Enclosure 2
Meeting Summary Handouts
of the March 30, 2011
ROP Public Meeting
Dated April 13, 2011

REACTOR OVERSIGHT PROCESS (ROP) MONTHLY PUBLIC MEETING AGENDA

Open FAQs on NEI 99-02
Status Date: For 3/30/2011 ROP Public Meeting

Figure F-6

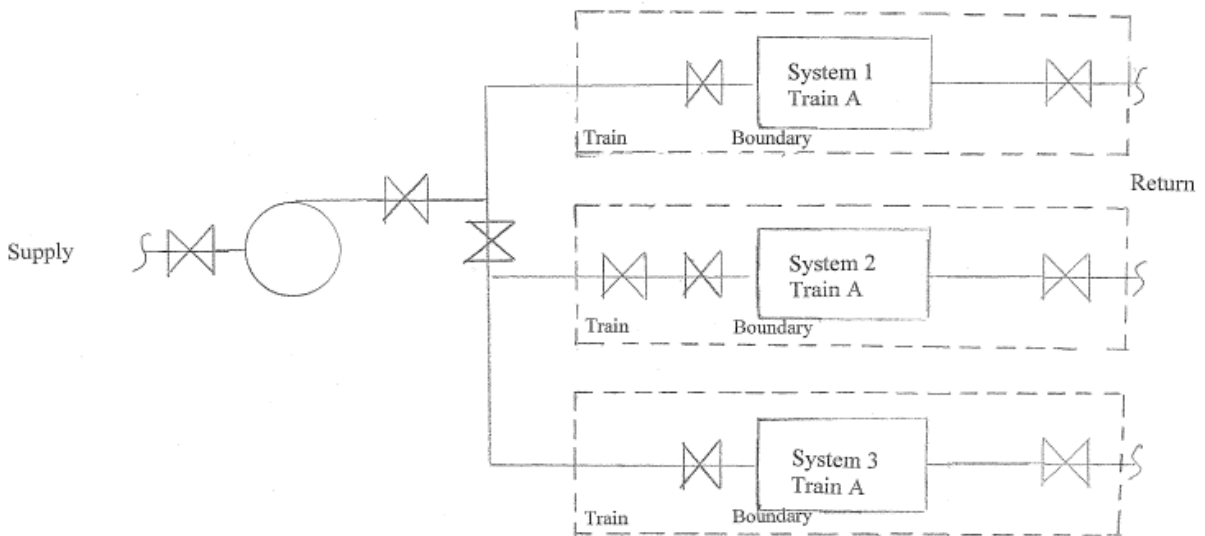
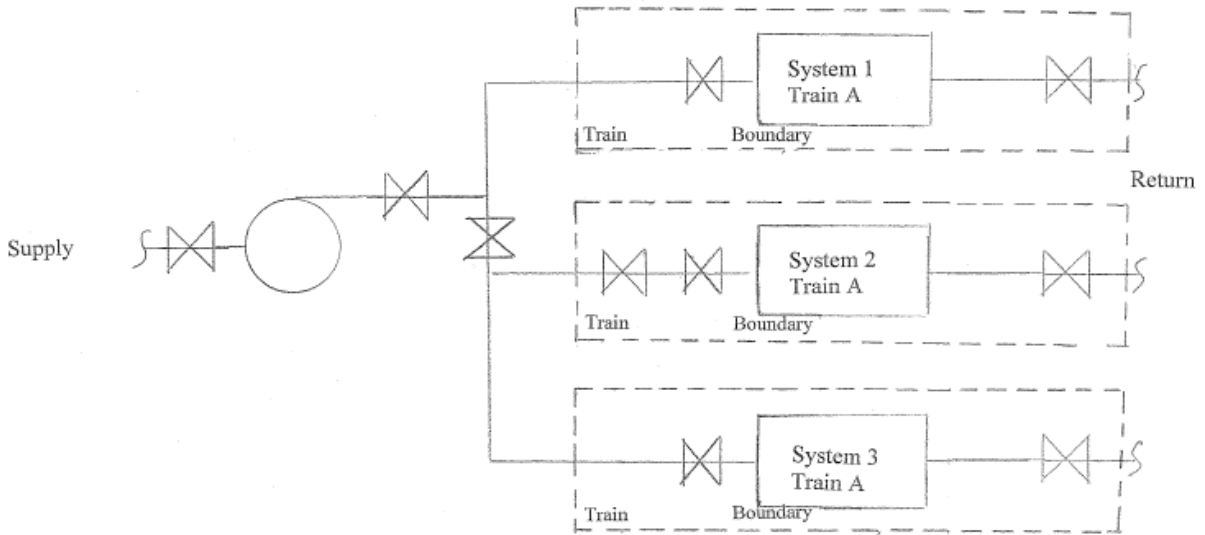
Question - Should a cooling water system isolation valve(s) in a line supplying a single monitored component be included in the monitored train's system boundary?

NEI 99-02, Rev. 6, provides guidance for the cooling water system scope on pages F-52 and F-53. The text from page F-53, lines 2 through 7, highlighted in italics below, indicates that only the last valve in a cooling water system line is included in the boundary of the monitored component. While this may be correct in most applications, there are plant configurations where a cooling water system line running to a monitored system (EDG for example) has more than one isolation valve (e.g., manual isolation valve(s)). If the isolation valve(s) were closed it would only result in supported train unavailability and would not affect the availability of the cooling water system. However, the guidance on page F-53, lines 2 through 7, could lead one to the opposite conclusion and suggest that the cooling water system would be unavailable.

Question - Should a cooling water system isolation valve(s) in a line supplying a single monitored component be included in the monitored train's system boundary?

Response – Yes, a cooling water system isolation valve(s) in a line supplying a single monitored train should be included in the monitored train's system boundary.

Revise NEI 99-02, Rev. 6, Page F-53, lines 1 through 9, to read as follows:

Response – Yes, a cooling water system isolation valve(s) in a line supplying a single monitored train should be included in the monitored train's system boundary.

Revise NEI 99-02, Rev. 6, Page F-53, lines 1 through 9, to read as follows:

necessary to provide cooling to the other monitored ~~systems-trains or segments~~ are included in the cooling water system scope up to, but not including, the ~~last~~ isolation valve(s) that connect(s) the cooling water support system to components in a single monitored ~~system~~ train or segment. This ~~these~~ last isolation valve is ~~is/are~~ included in the ~~other~~ monitored ~~system-train or segment~~ boundary. ~~If the~~ The last valve(s) that provides cooling to SSCs in more than one monitored ~~system or train~~ train or segment, then it is included in the cooling water support system. ~~If the cooling water line to a single monitored component or train contains components~~ All valves (e.g., manual isolation valves or motor operated valves (MOVs)) that would only affect the monitored component or train, those components in a cooling water line to single monitored train or segment are included in the ~~other system~~ monitored train or segment boundary. Figure F-1-6 depicts the treatment of multiple isolation valves. Service water systems are typically open “raw water” systems that use natural sources of water such as rivers, lakes or oceans. Component Cooling Water systems are typically closed “clean water” systems.

Page F-55, Figure F-1

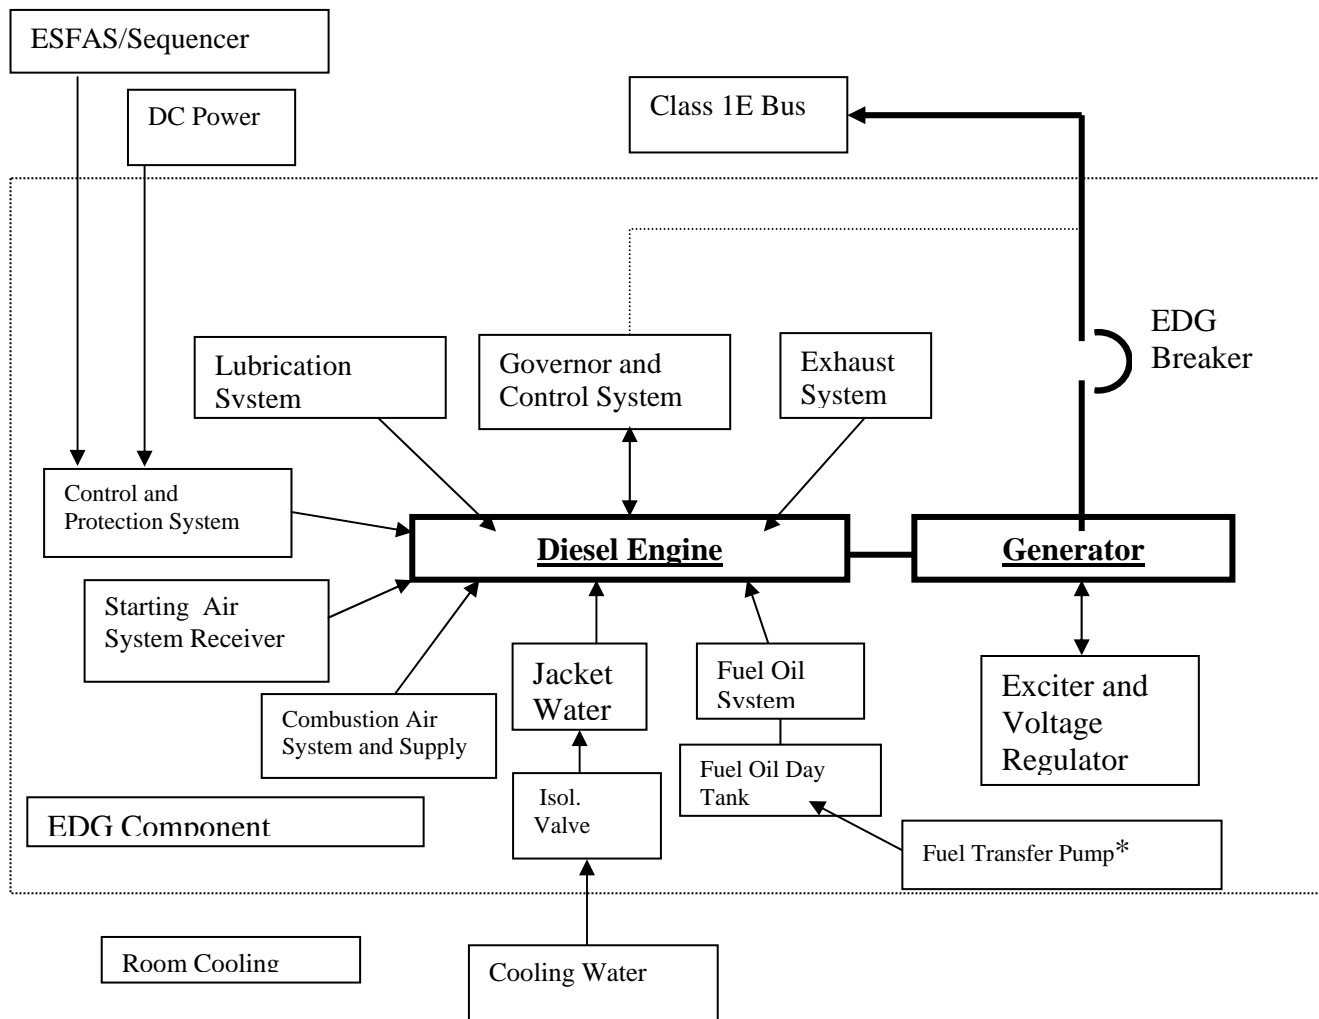
Revise NEI 99-02 section F.5 and Figure F-1 to include the Fuel Oil Transfer Pumps within the EDG super-component boundary.

The fuel transfer pumps required to meet the PRA mission time are within the ***EDG component system*** boundary, but are not considered to be a ***separate*** monitored component for reliability monitoring in the EDG system. Additionally they are monitored for contribution to train unavailability ~~only~~ if ***the fuel oil transfer pump(s) is (are) required to meet the EDG mission time***. ~~an EDG train can only be supplied from a single transfer pump. Where the capability exists to supply an EDG from redundant transfer pumps, the contribution to the EDG MSPI from these components is expected to be small compared to the contribution from the EDG itself. Monitoring the transfer pumps for reliability is not practical because accurate estimations of demands and run hours are not feasible (due to the auto start and stop feature of the pump) considering the expected small contribution to the index.~~

- The Fuel Transfer Pump is included in the EDG *Component* System Boundary. See Section 5 for monitoring requirements.
